# UNITED STATES PATENT AND TRADEMARK OFFICE

10/686,191

David L. Hagen

<b>Office Action Summary</b>	<b>Application No.</b> 10/686,191	<b>Applicant(s)</b> HAGEN ET AL.	
	<b>Examiner</b> Tony G. Soohoo	<b>Art Unit</b> 1797

FIG. 1

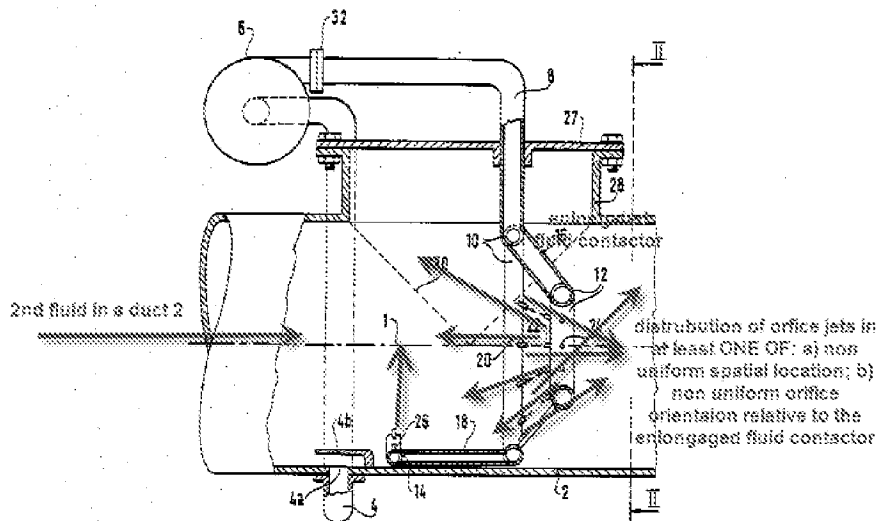
(a) **non-uniform spatial location** (see location of 26 compared to 20, 22, fig 1)

A desired flow distribution of the 1st fluid is provided by a plurality of outlet orifices nozzles, which as seen in figures 1 and 2, by a non-uniform distribution of spatial location and orientation.

Note that the fluid contactor tube is formed from a conical, curved, thin walled tubular member extending transverse and along parallel in curvature into the flow path of the 2<sup>nd</sup> flow. There is also an elongation section 18 along the path of the pipe 2. Each of the elongation sections have a curvature radii along the length as seen in figs 1 and 2.

FIG. 2

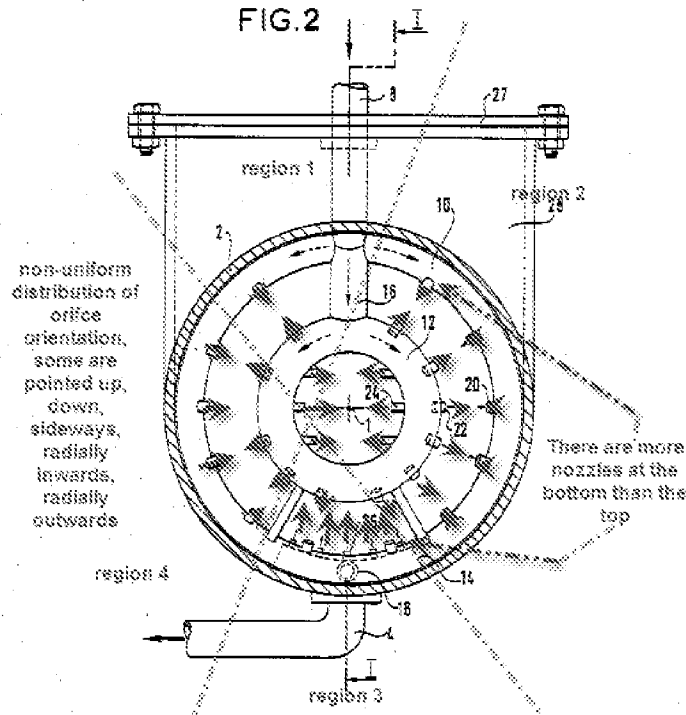
(c) **non uniform orientation** (see arrows fig 2), relative to **one of the choice of:** 1) the axial, 2) radial and 3) circumferential directions of the elongated fluid contactor, excluding a 1<sup>st</sup> or 2<sup>nd</sup> orthogonal directions transverse to the mean streamwise flow;

regions along the curvilinear path along the contactor surface having at least four differing regions along the curvilinear path along the “contractor” [sic] surface. (see markup figure with four exemplary regions)

24. However, it also shows at least four "regions" in the manner required by the claim as seen in the markup figure.
